| Title | Enhancements to 4 transmit antenna rate 2 space-time codes for the OFDMA PHY | |
| Re: | 802.16e/D5 | |
| Abstract | We propose improved space-time codes for 4 Tx rate 2. | |
| Purpose | To propose enhancements of the space-time codes in 802.16e/D4. | |

Figure 3: Performance comparison (uncoded) for the 4Tx-Rate 1 matrix B currently in the standard and the proposed matrix D for QPSK modulation in a flat Rayleigh fading channel with MMSE type receivers.

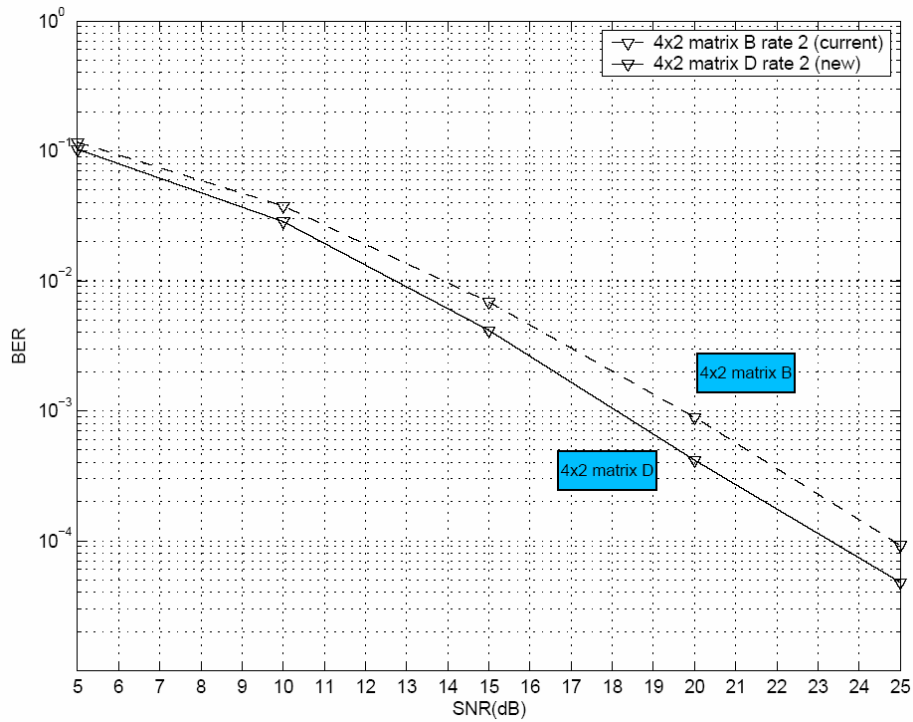
The proposed code gives more coding gain than the current transmission matrix B with MMSE detection as shown in Figure 2.
